**ADDENDUM
NO. 3**

June 9, 2023

**LAKE STREET ELEMENTARY SCHOOL ADDITIONS, RENOVATIONS,
AND RELATED WORK
Crown Point, IN 46307**

Addendum Three (AD.03) to the drawings and specifications prepared by Gibraltar Design for **Lake Street Elementary School Improvements** for Crown Point Community School Corporation, Crown Point, Indiana.

© GIBRALTAR DESIGN SHEET
EL101

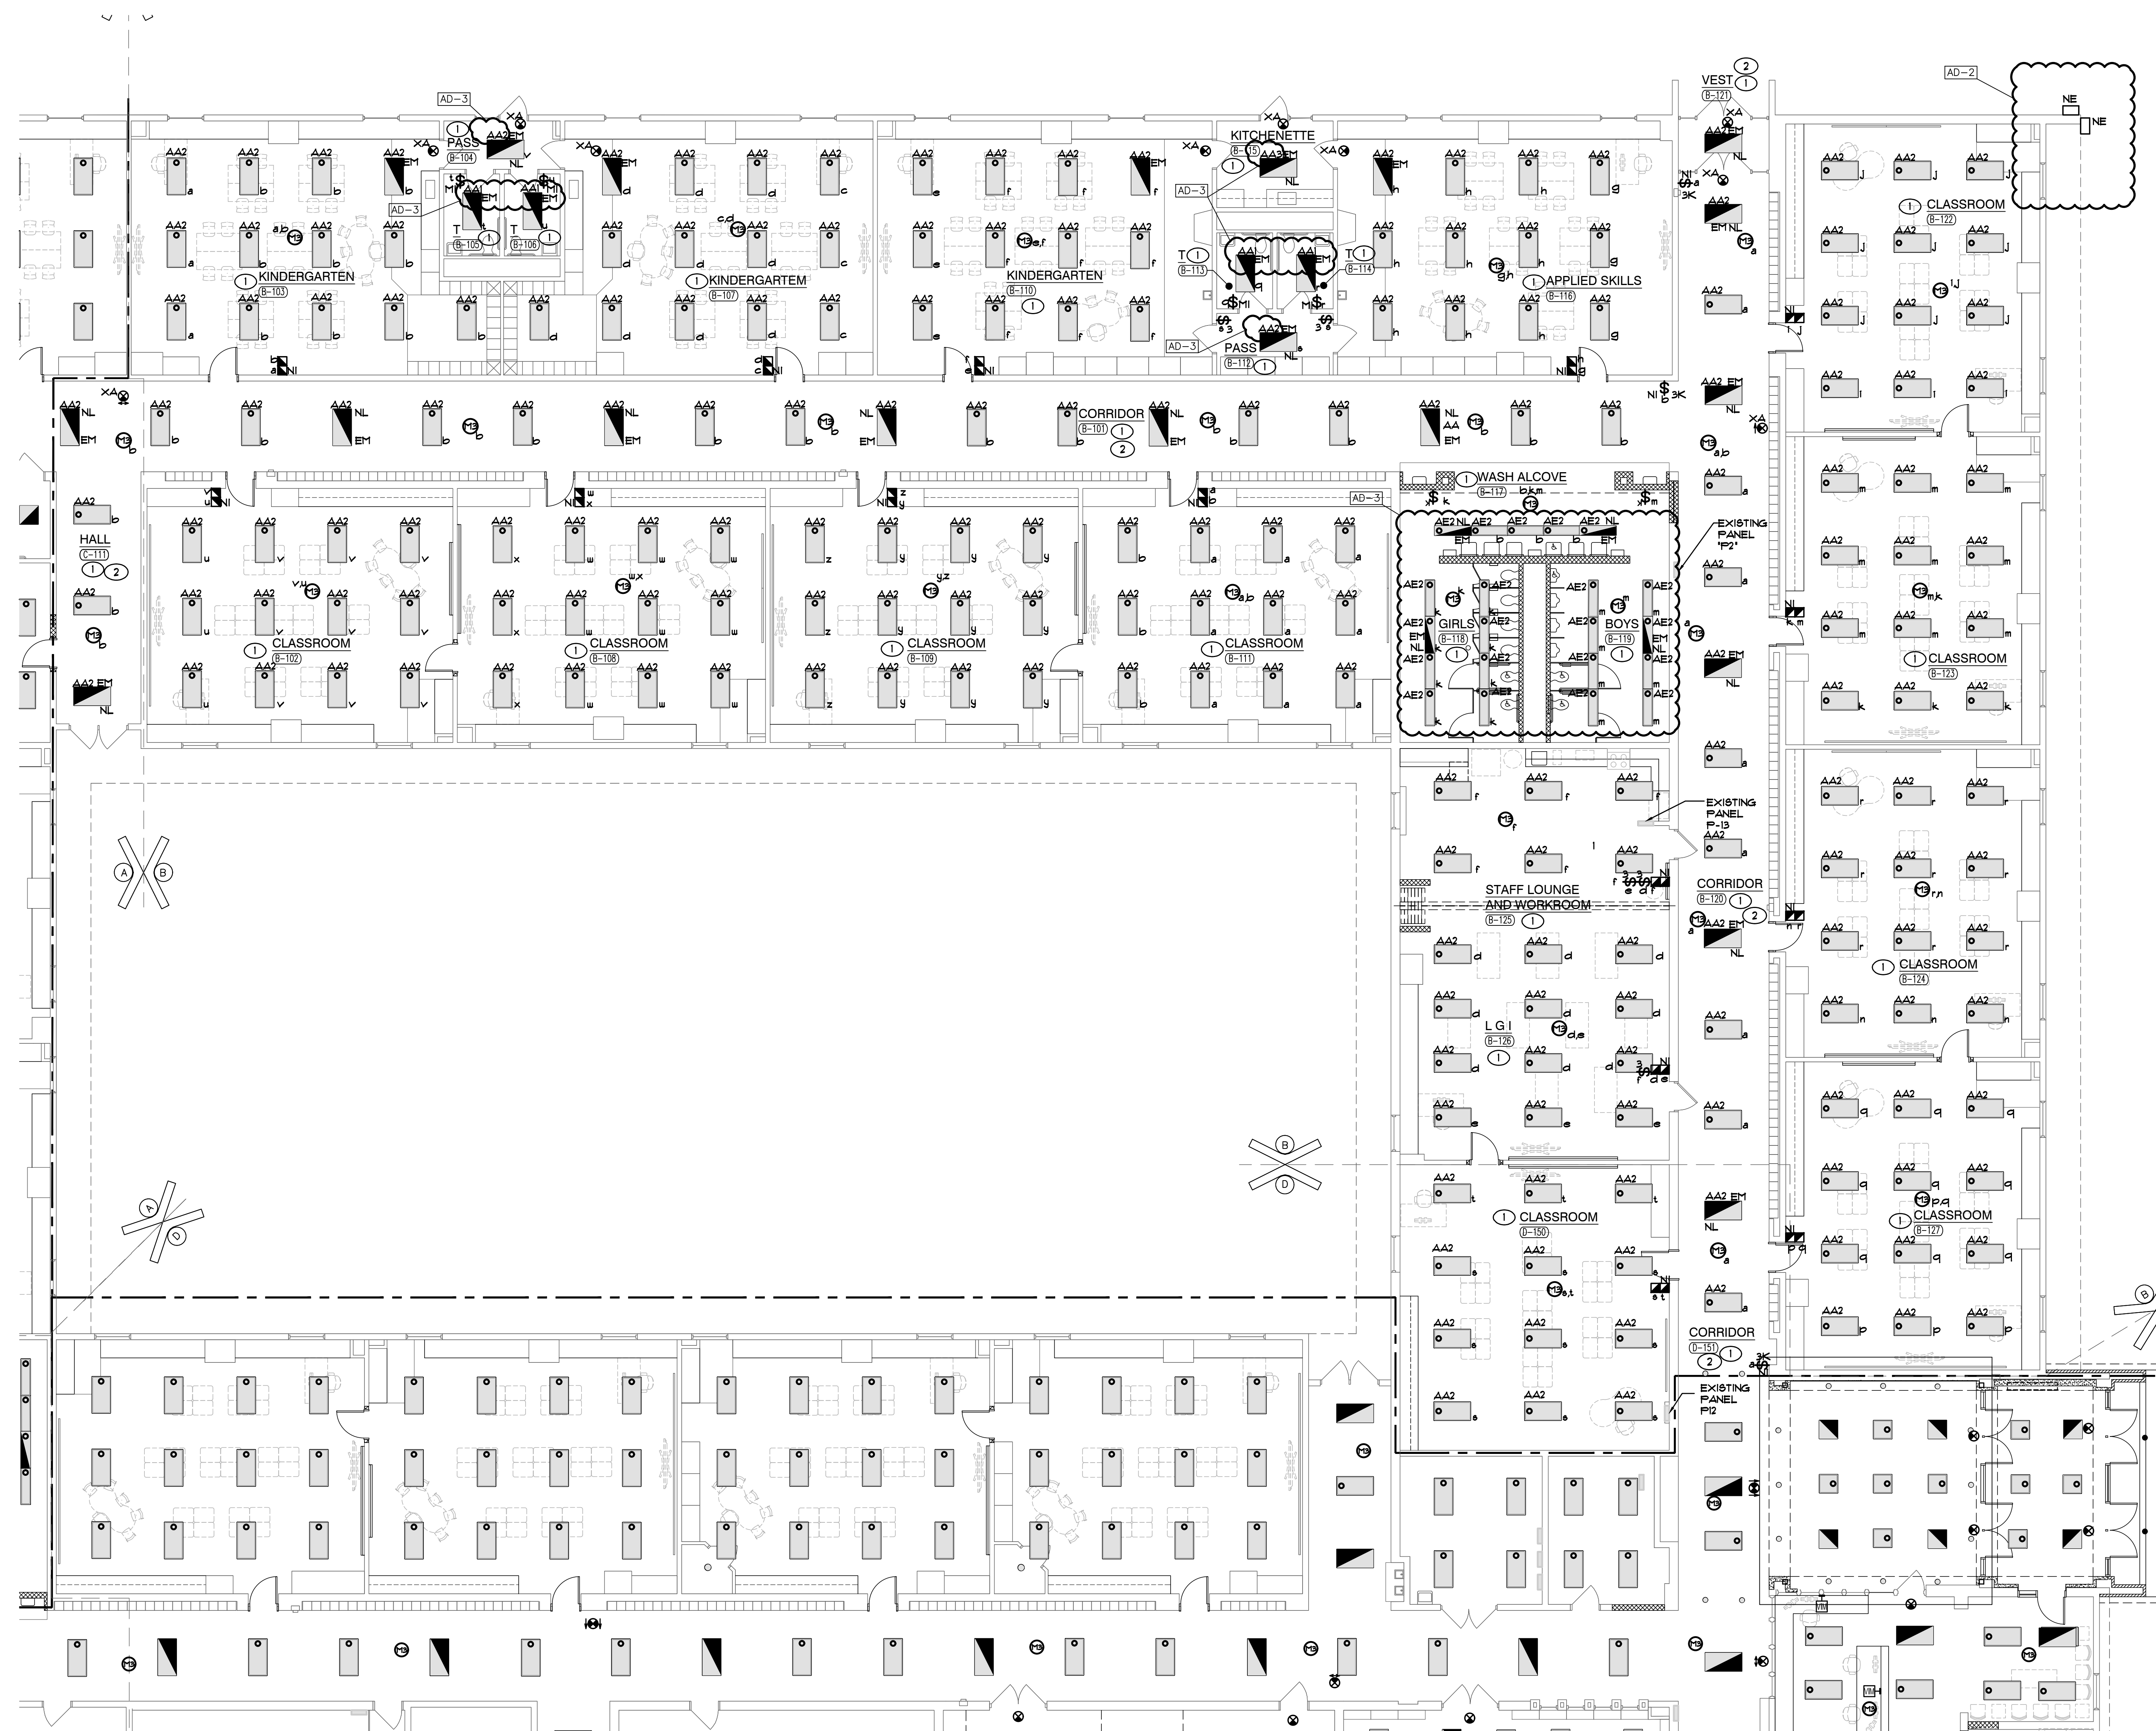
12. Sheet EL-101

1. Revised light fixture tags.

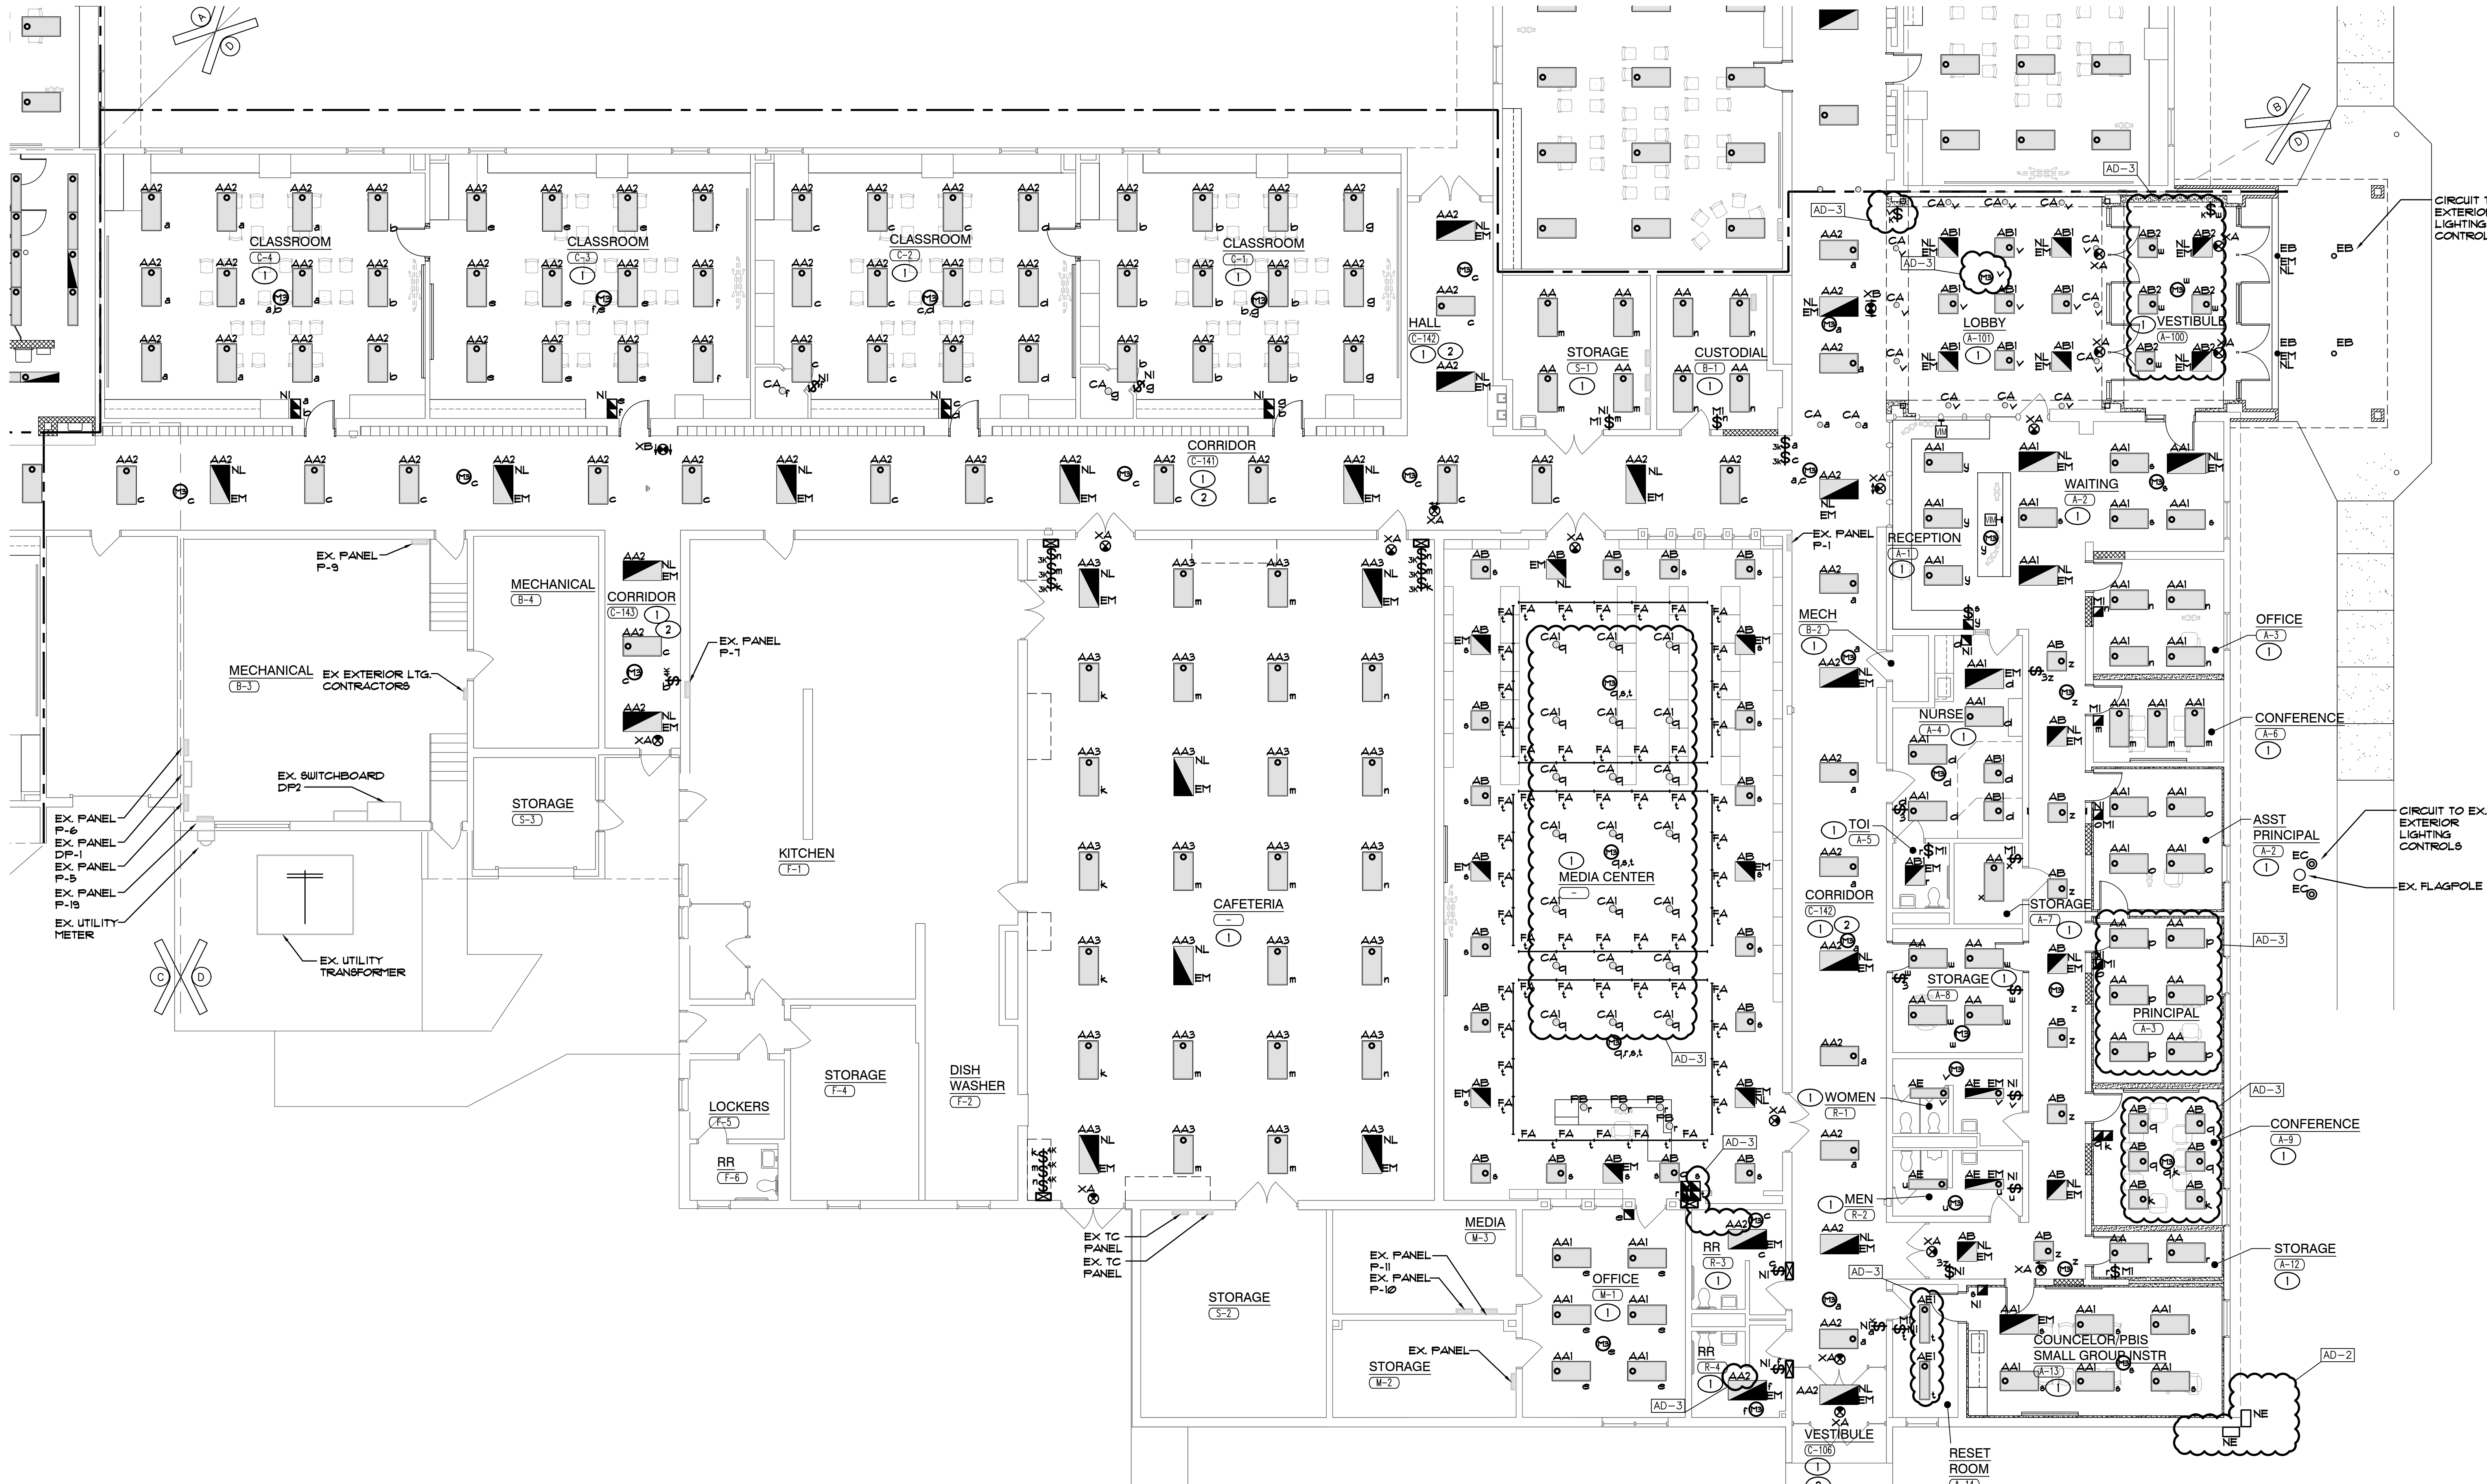
14. Sheet EL-103

1. Revised light fixture tags.

© GIBRALTAR DESIGN SHEET
EP103

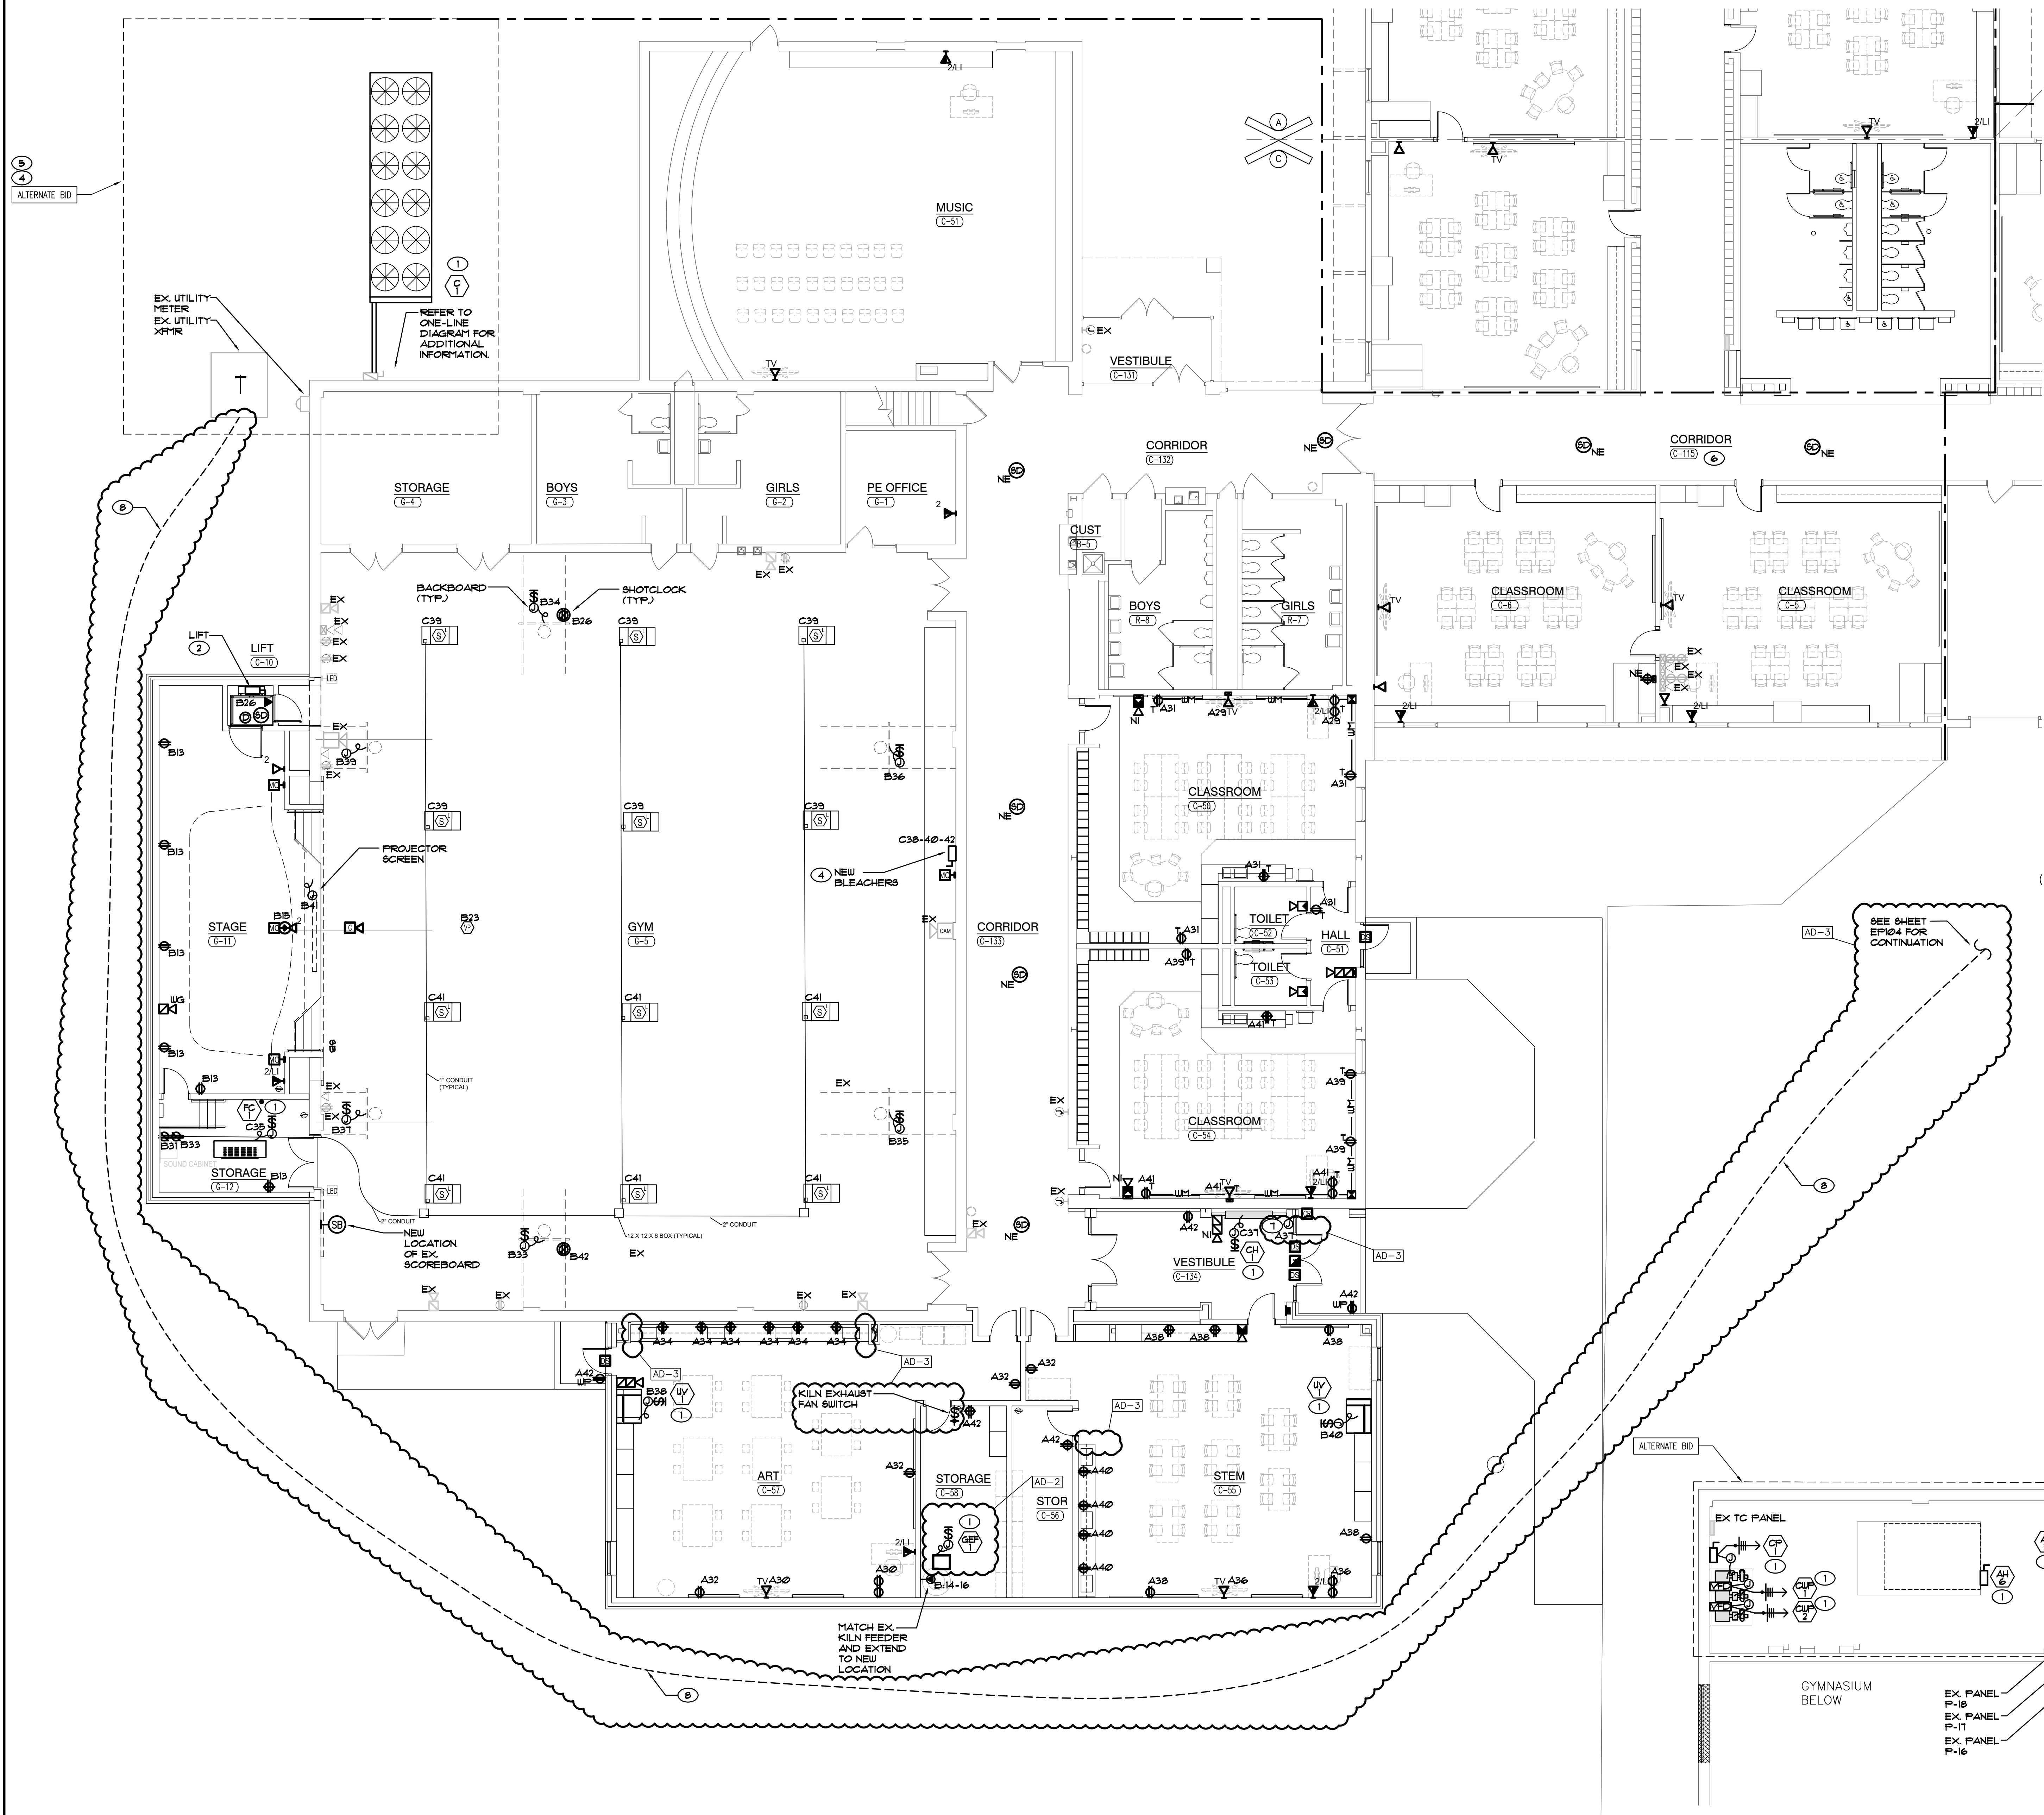
16. Sheet EP-103

- A. Refer to revised, full-size drawing, included in this Addendum, for the following revisions:
 - 1. Added access control power.
 - 2. Removed receptacles.
 - 3. Added sheet notes.
 - 4. Added pilot light switch.
 - 5. Added relocation of primary feeder
